EDWIN I. HATCH NUCLEAR PLANT, UNIT NO. 1

Amendment No. 87
License No. DPR-57

ATTACHMENT TO LICENSE AMENDMENT NO. 87

SAFETY EVALUATION BY THE OFFICE OF NUCLEAR REACTOR REGULATION
SUPPORTING AMENDMENT NO. 87 TO FACILITY OPERATING LICENSE NO. DPR-57

Fuel Type P8DRB284

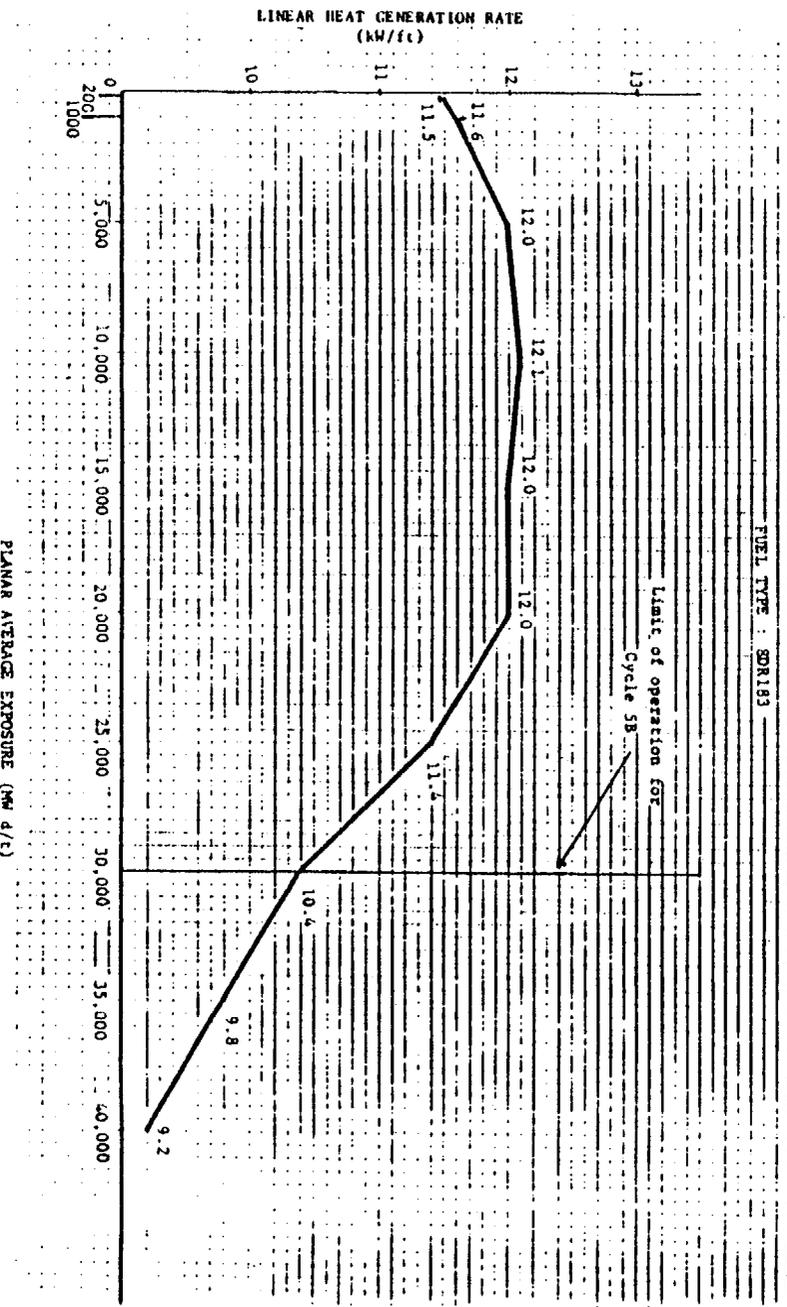
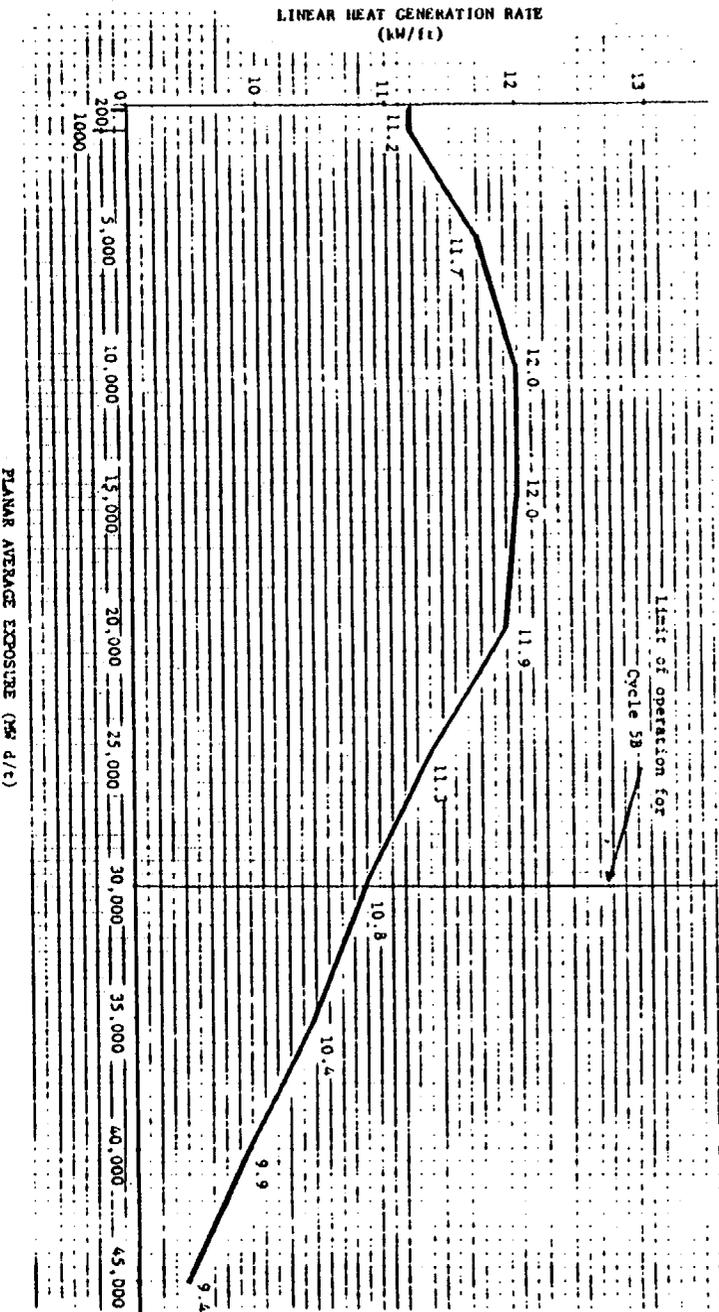
During power operation, the APLHGR for each type of fuel as a function of average planar exposure shall not exceed the limiting value shown in Figure 3.11-1, sheets 1, 2 and 3. If at any time during operation it is determined by normal surveillance that the limiting value for APLHGR is being exceeded, action shall be initiated within 15 minutes to restore operation to within the prescribed limits. If the APLHGR is not returned to within the prescribed limits within two (2) hours, then reduce reactor power to less than 25% of rated thermal power within the next four (4) hours. If the limiting condition for operation is restored prior to expiration of the specified time interval, then further progression to less than 25% of rated thermal power is not required.

The licensee's proposed MAPLHGR limits for the replacement fuel have been calculated using previously approved methods presented in the General Electric Company (GE) letter of May 28, 1981, entitled, "Additional Information Regarding Extension of Emergency Core Cooling System Performance Limits." We conclude that these revised TS curves are acceptable.

MCPR LIMIT FOR 8X8R FUEL
FIGURE 3.11.4

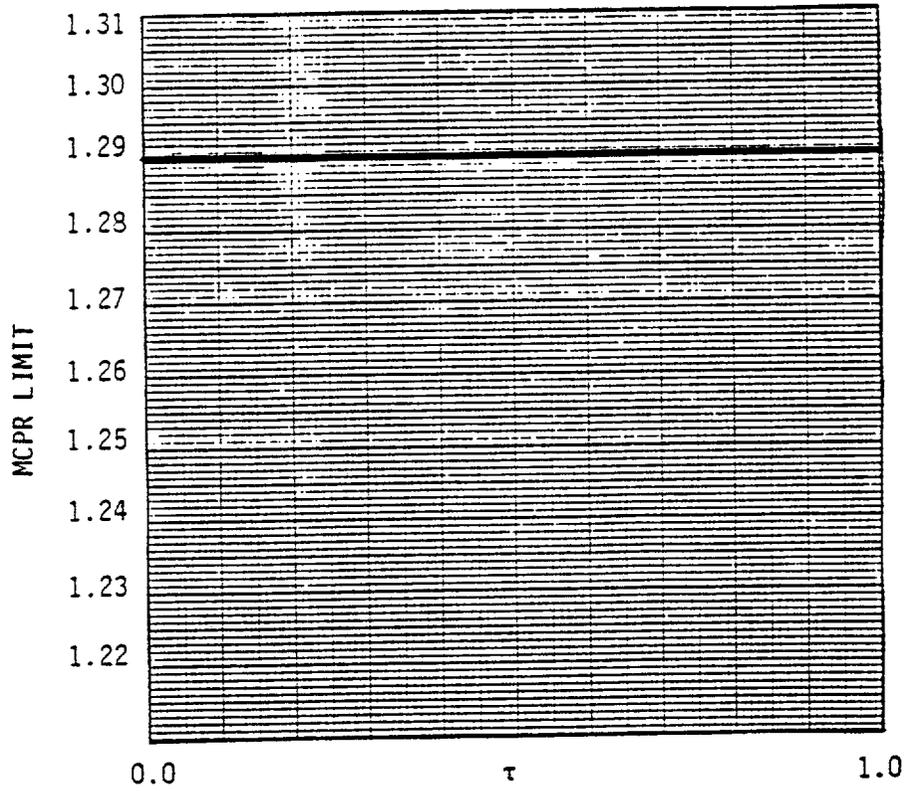
GPC requested a TS change for Hatch 1 for the Rod Block Monitor (RBM) setpoint to 107 percent and the MCPR limit for all fuel type to 1.29. The limit values are based on the rod withdrawal event (RWE).

For the present Hatch 1 replacement fuel, the information is sufficient to conclude that the MCPR value of 1.29 for all fuel types when using a RBM setting of 107, based on the statistical analyses of RWE, is sufficient to provide a suitable limit without the need for a cycle specific analysis and is thus acceptable.
